1. Background
2. ICCT proposal: noise and health issues
3. Standardization work – ISO5130
4. ECE regulations and the way forward

- In this presentation, I will give some comments to the presentation from ICCT, both regarding the challenges of having a NTE limit, as well its relevance for health and annoyance.

Fig. 6. Scatterplot and quadratic regression of the relationship between road traffic noise (L_{den}) and annoyance (%HA)

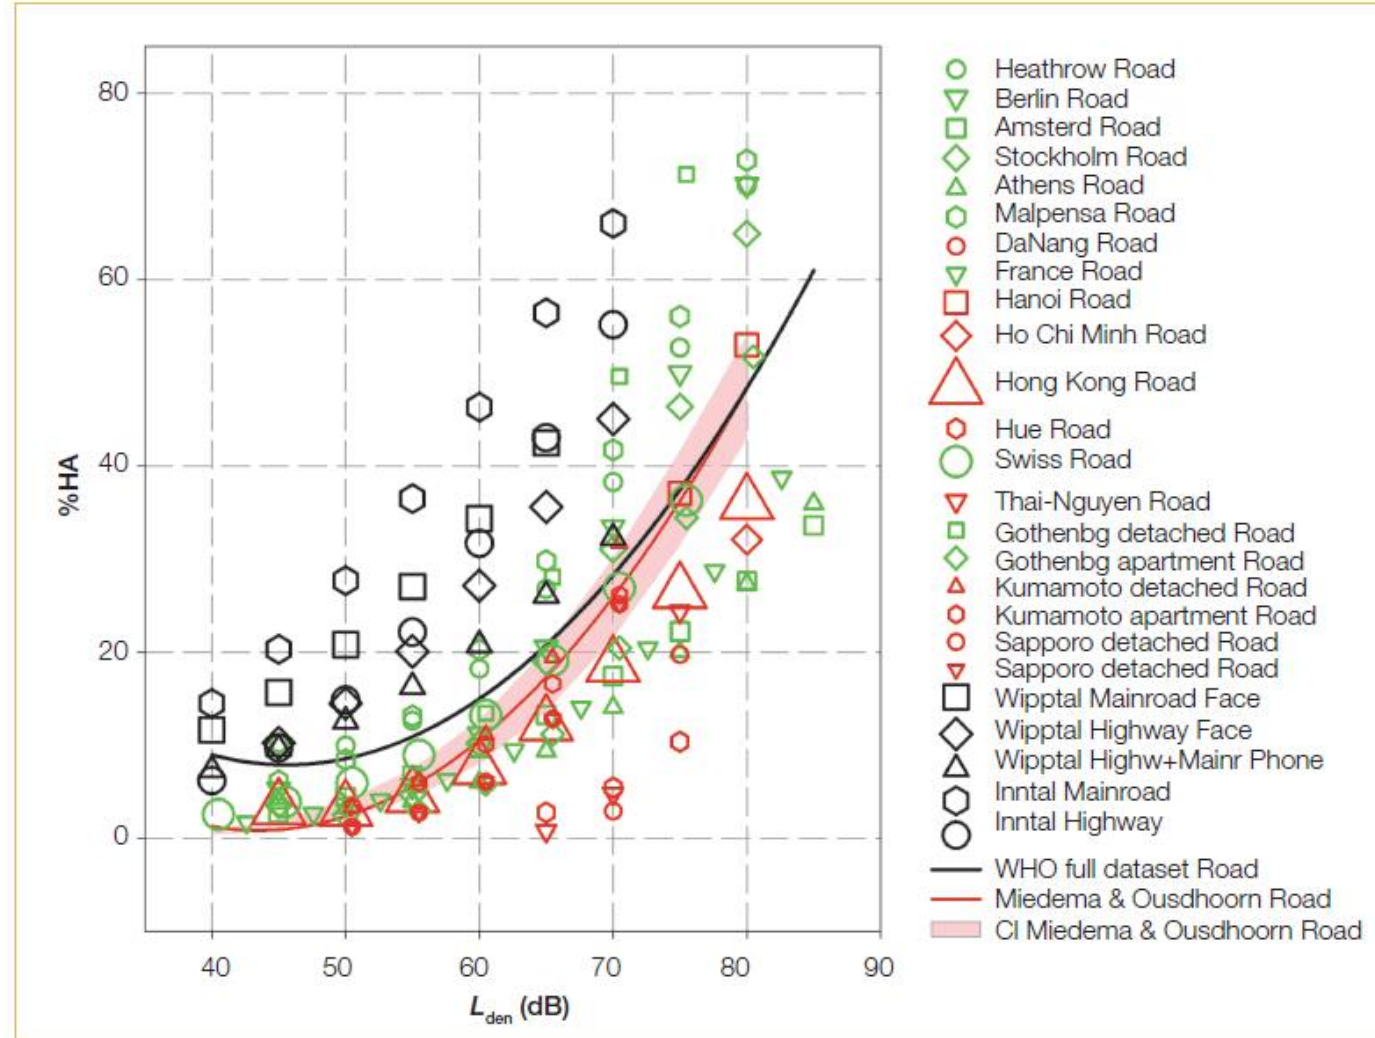
- In general, the World Health Organization, WHO, recognize a relationship between noise exposure, annoyance and health issues (WHO Environmental Noise Guidelines for Europe, 2018). However, this relationship is based on international investigations between annoyance and exposure, defined by an ***equivalent noise indicator Lden*** (Weighted day-evening-night sound level) – see next slide
- In addition to Lden, Lnight is the second indicator used by WHO. Lnight can include single noise events. However, the Lnight is, as Lden, an ***energy-based*** indicator.

Figure 7. Relationship between average annoyance and personal noise exposure expressed as maximum noise level in 5 dB(A) classes.

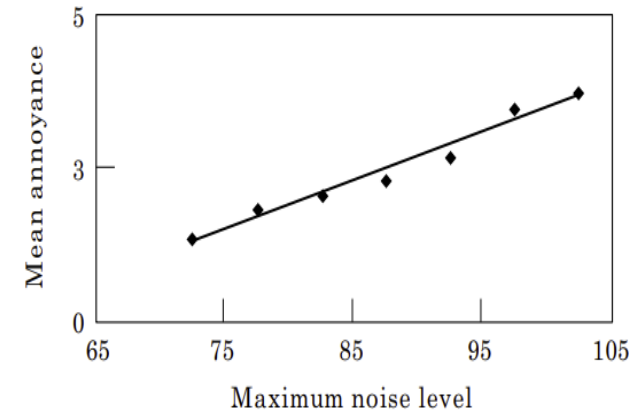
L_{Amax} and annoyance, ICCT and reference to SATO et al, 1999:

A limit of 95 dBA at 0.5 m: Annoyance Scale = 3
Point source: 83 dB at 2 m ~ 2.5 on the scale
and 71.5 dBA at 7.5 m: 2=Notice –not annoyed
